## REVISED RESPONSE TO REQUEST FOR ADDITIONAL INFORMATION

### APR1400 Design Certification

Docket No. 52-046

**RAI No.:** 283-8229  
**SRP Section:** 14.02 – Initial Plant Test Program - Design Certification and New License Applicants  
**Application Section:** 14.2  
**Date of RAI Issue:** 11/02/2015

5.6

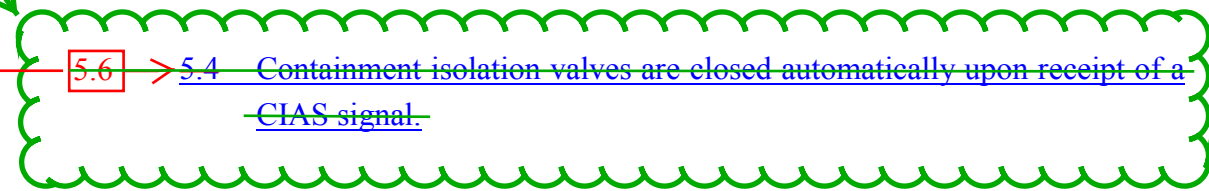
Delete

→ ~~5.4~~ Containment isolation valves are closed automatically upon receipt of a ~~CIAS~~ signal.

Since the test for the containment isolation valve operation of gaseous radwaste system will be performed in accordance with Section 14.2.12.1.129, Section 14.2.12.1.105 will be revised as indicated in Attachment to this response.
